***MODIFICATION REQUEST:  
Marrickville Metro Shopping Centre  
Expansion – Concept Plan (Stage 1)***

***Marrickville Metro – 34 Victoria Road and 13-55  
Edinburgh Road, Marrickville***

***MP09\_0191 MOD1***

Director-General's  
Environmental Assessment Report  
Section 75W of the  
*Environmental Planning and Assessment Act 1979*

**Figure 8: Tree removal plan (Source: proponent's Environmental Assessment)**

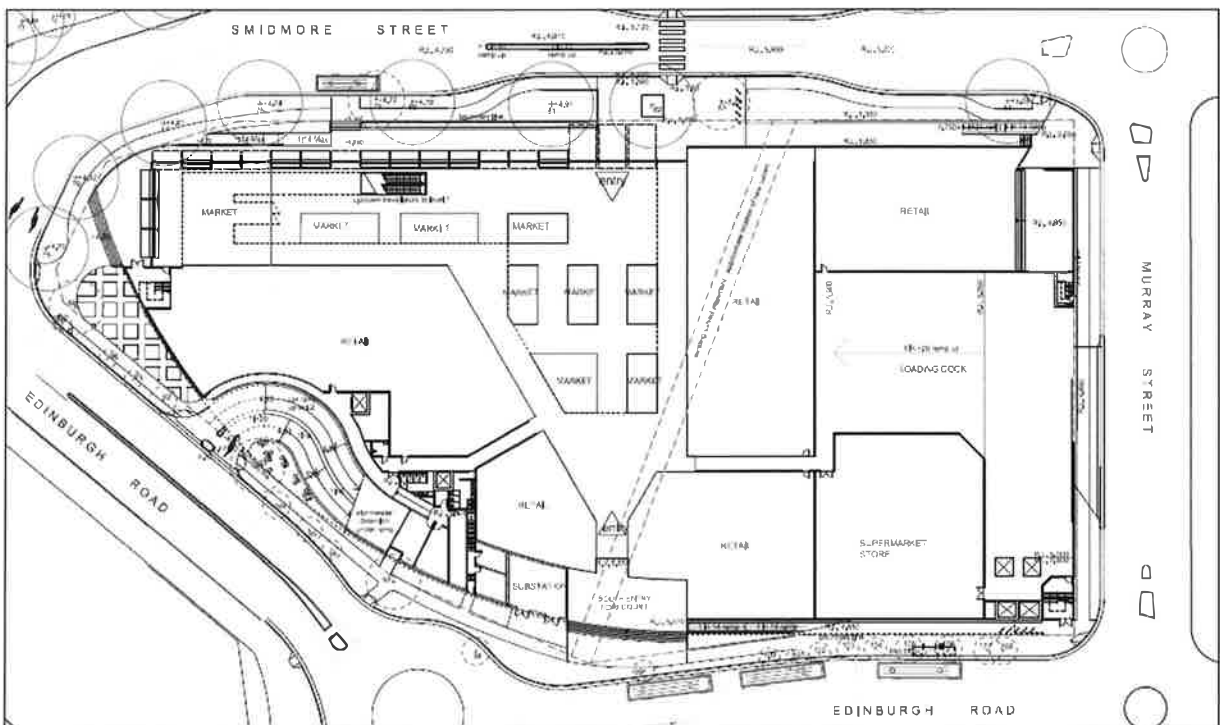
The modification proposes the removal of 23 trees from the Edinburgh Road site (21 from Edinburgh Road and 2 from Smidmore Street), refer to **Figure 8**. A landscaping strategy for the Edinburgh Road site is proposed, which includes the provision of 30 replacement trees (refer to **Figure 9**) as follows:

Five trees proposed to be removed are noted within the Proponent's Arboricultural Assessment as having 'moderate landscape significance', in particular these are:

- T79 and T83: Small Leaf Peppermint, only of fair health and life expectancy of 5-15 years
- T88: Lemon Scented Gum, located at junction of masonry walls, has potential to reach greater size
- T93 and T97: Broad-Leafed Paperbark, repeated lopping due to powerline clearance, trees have developed poor asymmetrical crowns.

The Department considers the removal of the 18 trees of 'low landscape significance' to be acceptable given they are of low significance and the good quality of the replacement street tree planting shown in the landscape masterplan.

- although T79 and T83 are of fair health and contribute to the visual amenity of the streetscape, they are of a noticeably poorer standing than the surrounding lemon scented eucalypts being retained. The removal of these two trees would result in a uniform street tree presence and therefore an improvement in the overall streetscape;
- T88 is poorly located with regard to the development and is likely to conflict with the development if allowed to reach full maturity; and
- the removal of T93 and T97 have suffered ongoing and extensive pruning, which has adversely distorted their form.

The Department considers the removal of the 5 trees of 'moderate landscape significance' to be acceptable given that those trees are each compromised in some way and their removal would facilitate the good landscaping solution for the Edinburgh Road site as proposed by the modification.

**Figure 9: Landscaping plan (Source: proponent's Environmental Assessment)**

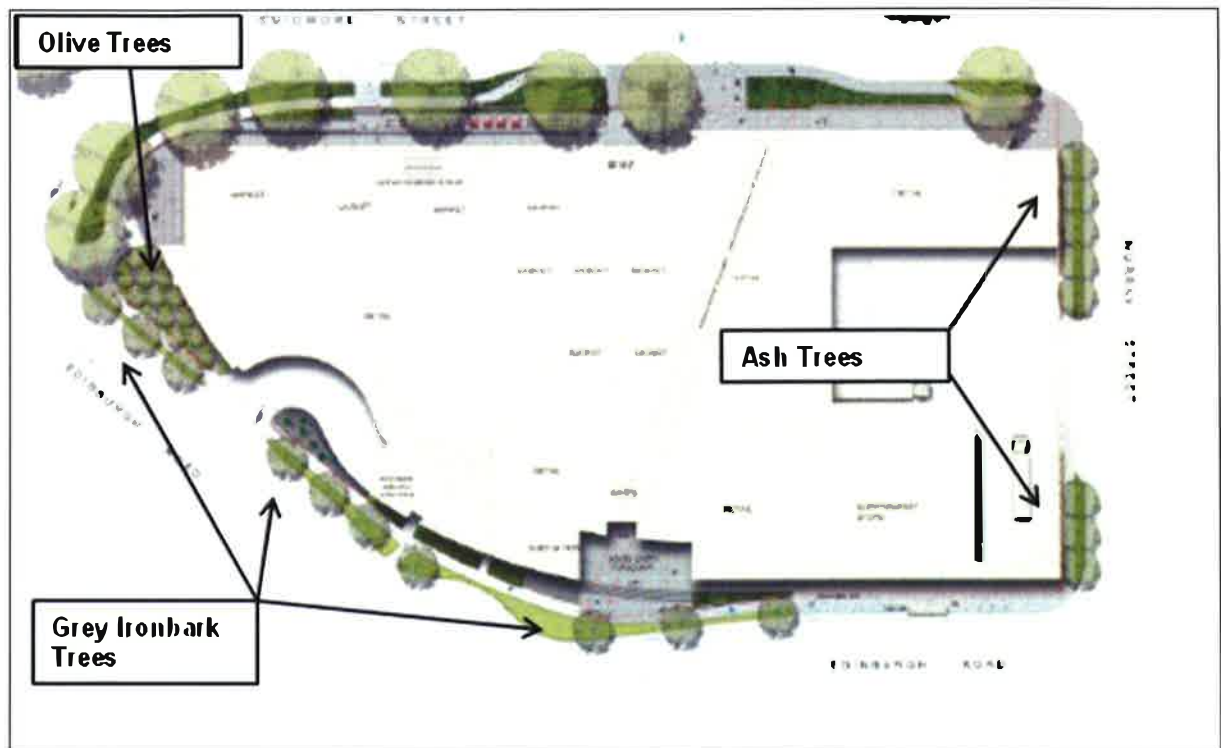
Marrickville Council did not object to the proposed tree removal strategy and landscaping plan subject to the imposition of new conditions regarding:

- the potential sale of the palm trees to be removed;
- tree protection specifications;
- monitoring and certification by arborist;
- soil moisture monitoring and irrigation;
- tree pit design; and
- location of electrical cables.

The proponent has agreed to relocate/transplant the 4 cabbage palm trees and a new condition (Condition D35) is recommended accordingly. The Department notes that matters relating to tree protection, monitoring, soil moisture, tree pit design and electrical cables were all addressed and conditioned as part of the original approval (Conditions D17, D28 and D31).
